In re Patent No. 6,032,898

Title: MULTIPLE ROLL TOWEL DISPENSER

### PETITION FOR CERTIFICATE OF CORRECTION PURSUANT TO 37 C.F.R. §§ 1.322 and 1.323

Replacement Sheet 1 of 4

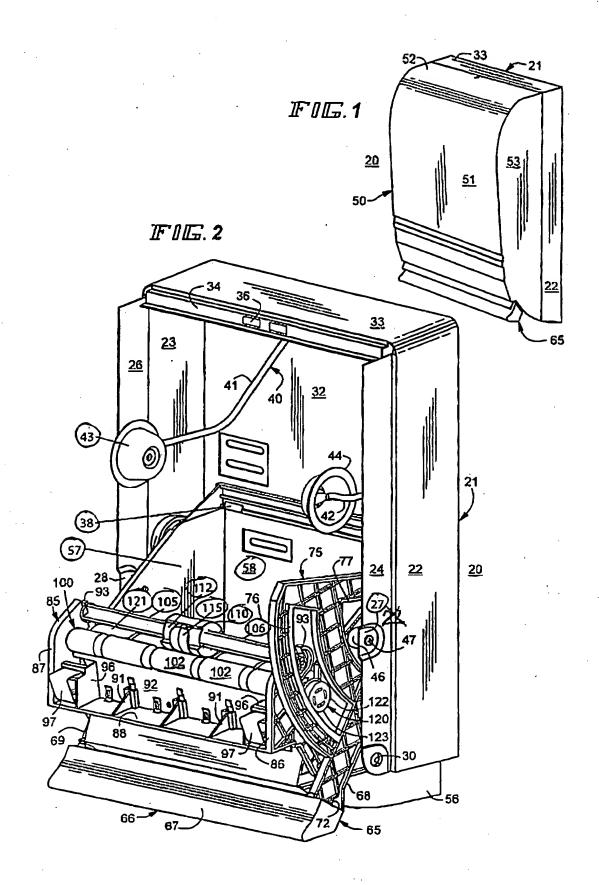
In the drawings, sheet 1, Fig. 2, reference numeral "22" on the sidewall of outwardly extending flange 24 should be deleted and reference numeral --27-- should be applied to the stamped portion;

In the drawings, sheet 1, Fig. 2, reference numeral -43-- should be applied to the lefthand side hub of the paper roll holder assembly 40; reference numeral --58- should be applied to

the rear wall of the chassis 55; reference numeral -57- should be applied to the left-hand side spaced parallel side wall of chassis 55; reference numeral -38-- should be applied to the clip extending from the rear wall 32 of the housing 21.

In the drawings, sheet 1, Fig. 2, reference numeral --121-- should be applied to the drive roller segments of the drive roller 120.

In the drawings, sheet 1, Fig. 2, reference numeral -105- should be applied to the transfer roller assembly; reference numeral -106- should be applied to the shaft 106 of the transfer roller assembly 105; reference numeral -110- should be applied to the transfer mechanism; reference numeral -112- should be applied to the indented or removed portion of the cylindrical portion 111 of the shaft 106; reference numeral --115- should be applied to the snap clip which receives the indented or removed portion 112 of the cylindrical portion 111 of the shaft 106.

Regarding the figures, petitioner has submitted herewith a red-line version of the figures requiring correction and replacement sheets for those figures. Additions to the figures are shown in red and are circled. Deletions are in red and are marked with an "X." Regarding Figures 2 and 11-17, the figures as filed included numerous part numbers which were not shown in the issued patent. Figures 6 and 10 have been amended to correct a reference number, as noted. Such changes do not constitute new matter.

Multiple Roll Towel Dispenser
Inventor: LaCount et al.
U.S. Patent No. 6,032,898
Atty Docket No. ALW-113REX
Red-Lined Version
Replacement Sheet 2 of 4

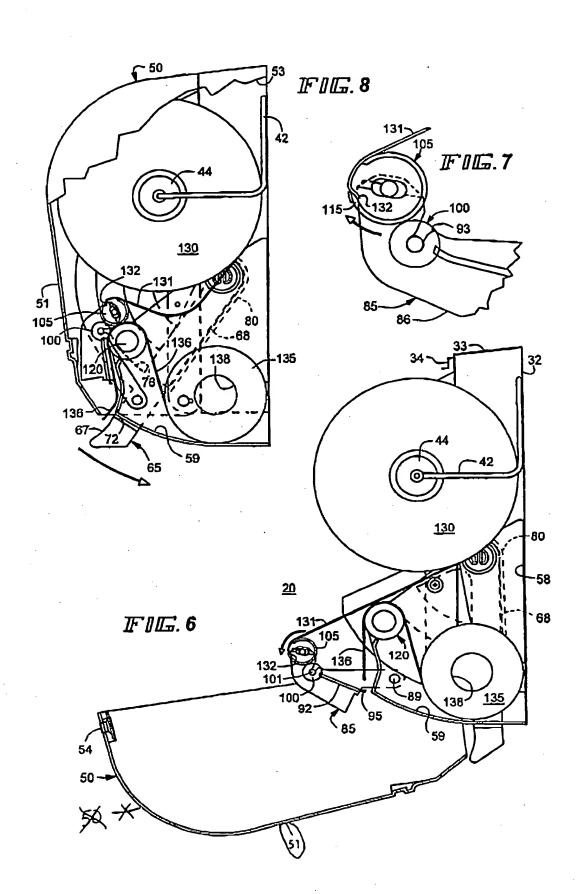
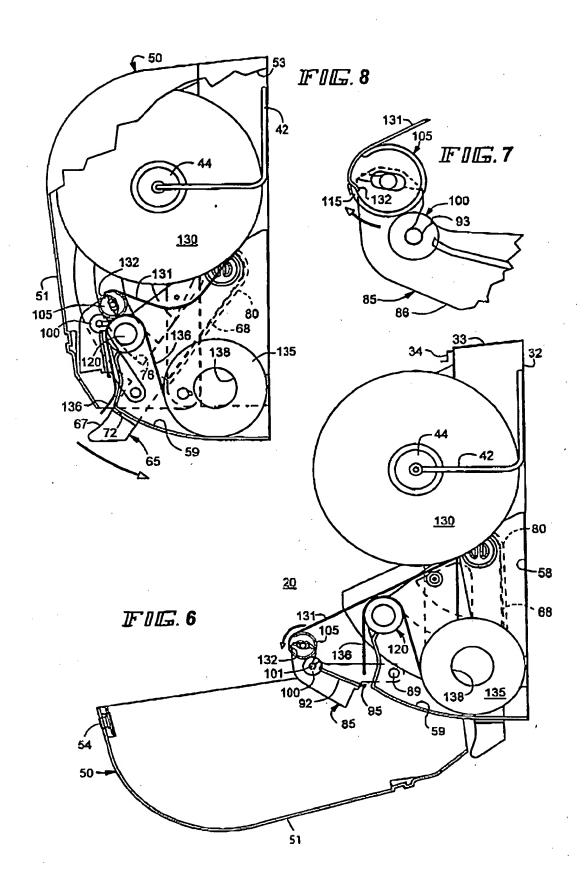
In the drawings, sheet 3, Fig. 6, the reference numeral "50" (not the reference numeral "50" pointing to the cover) should be deleted and reference numeral -51-- should be applied to the front panel of the cover 50.

Multiple Roll Towel Dispenser
Inventor: LaCount et al.
U.S. Patent No. 6,032,898
Atty Docket No. ALW-113REX
Red-Lined Version
Replacement Sheet 3 of 4

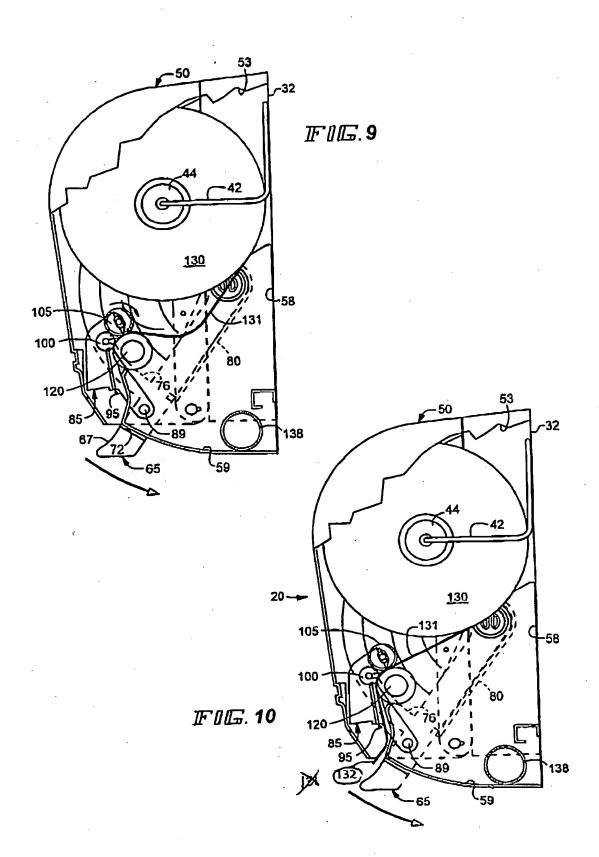
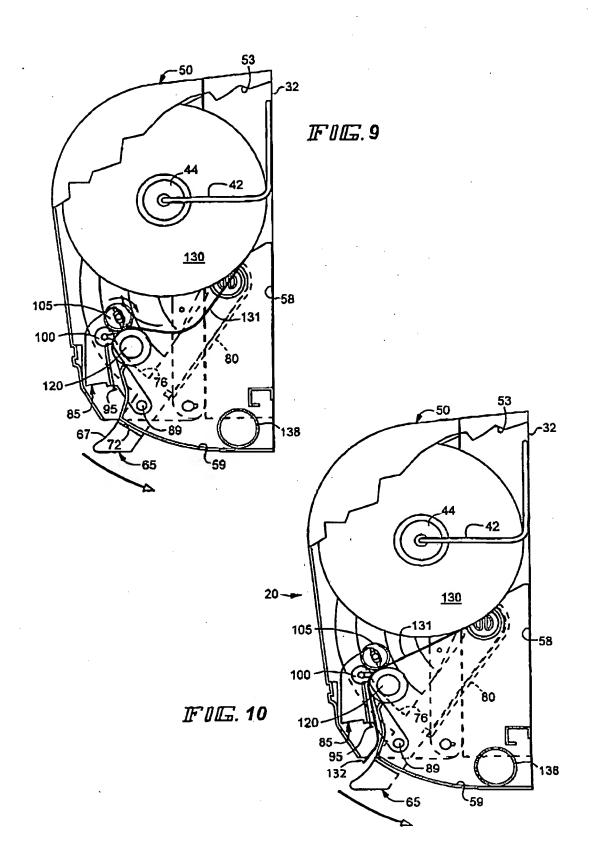
In the drawings, sheet 4, Fig. 10, the reference numeral "131" pointing to the free end of the flight of paper 131 should be deleted and the reference numeral --132-- should be applied to the free end of the flight of paper 131.

Multiple Roll Towel Dispenser
Inventor: LaCount et al.
U.S. Patent No. 6,032,898
Atty Docket No. ALW-113REX
Red-Linco Version
Replacement Sheet 4 of 4

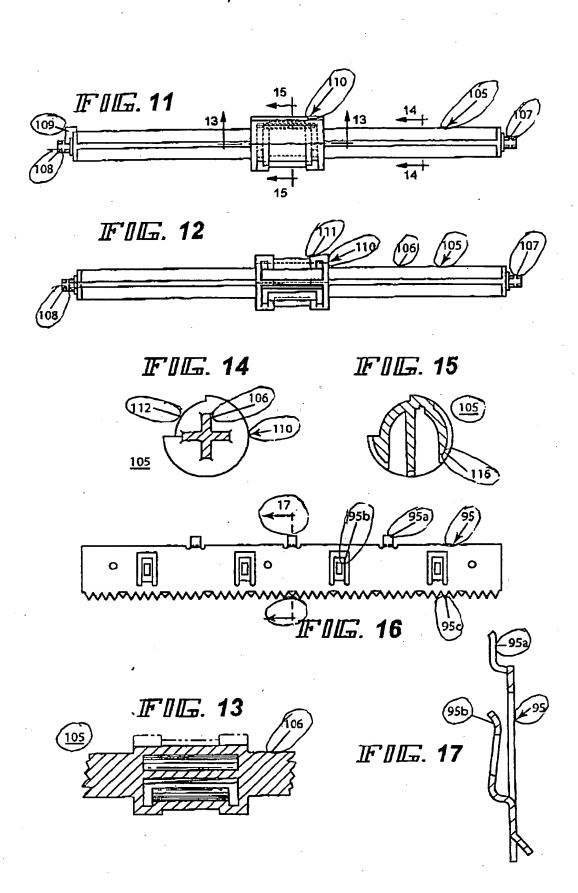
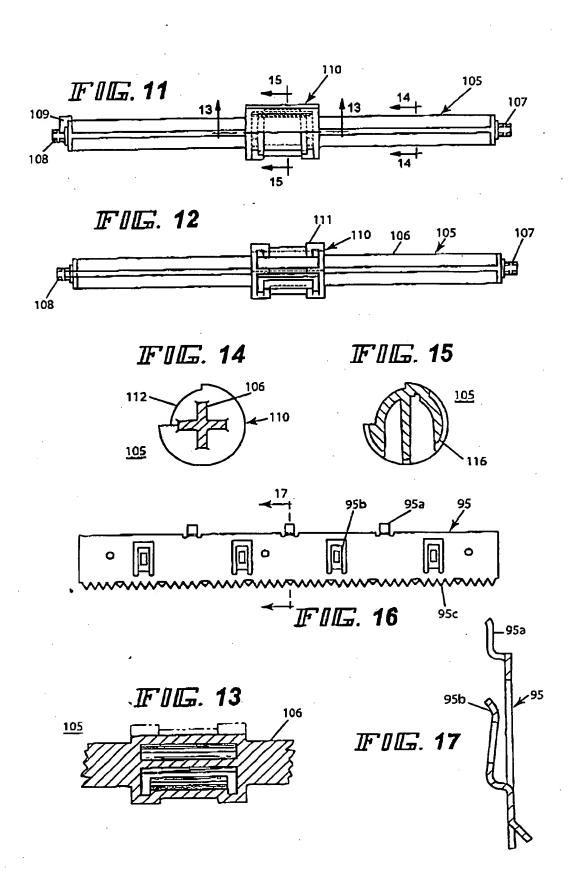
In the drawings, sheet 5, Fig. 11, reference numeral --105-- should be applied to the transfer roller assembly; reference numeral --107-- should be applied to the journal on the right-hand end of the transfer roller assembly 105; reference numeral --108-- should be applied to the

journal on the left-hand end of the transfer roller assembly 105; reference numeral -109- should be applied to the stop plate on journal 108; and reference numeral -110- should be applied to the transfer mechanism positioned generally centrally of the shaft of the transfer roller assembly 105.

In the drawings, sheet 5, Fig. 12, reference numeral --105— should be applied to the transfer roller assembly; reference numeral --106— should be applied to the shaft of the transfer roller assembly 105; reference numeral --107— should be applied to the journal on the right-hand end of the transfer roller assembly 105; reference numeral --108--- should be applied to the journal on the left-hand end of the transfer roller assembly 105; reference numeral --110--- should be applied to the transfer mechanism positioned generally centrally of the shaft 106; and reference numeral --111--- should be applied to cylindrical portion of the shaft 106.

In the drawings, sheet 5, Fig. 13, reference numeral --105-- should be applied to the transfer roller assembly; and reference numeral --106-- should be applied to the shaft of the transfer roller assembly.

In the drawings, sheet 5, Fig. 14, reference numeral -105-- should be applied to the transfer roller assembly; reference numeral --106-- should be applied to the shaft of the transfer roller assembly 105; reference numeral --110-- should be applied to the transfer mechanism positioned generally centrally of the shaft 106; and reference numeral --112-- should be applied to the indented or removed portion of the cylindrical portion 111 of the shaft 106.

In the drawings, sheet 5, Fig. 15, reference numeral --105-- should be applied to the transfer roller assembly; and reference numeral --116-- should be applied to the groove or

receptacle of the cylindrical portion 111 of the shaft 106.

In the drawings, sheet 5, Fig. 16, reference numeral -95- should be applied to the tear bar, reference numeral -95a- should be applied to the tabs of the tear bar 95; reference numeral -95b- should be applied to the clips of the tear bar 95; reference numeral -95c- should be applied to the serrated edge of the tear bar 95; and section line 17-17 should be added at the middle portion of the drawing at the top and bottom thereof.
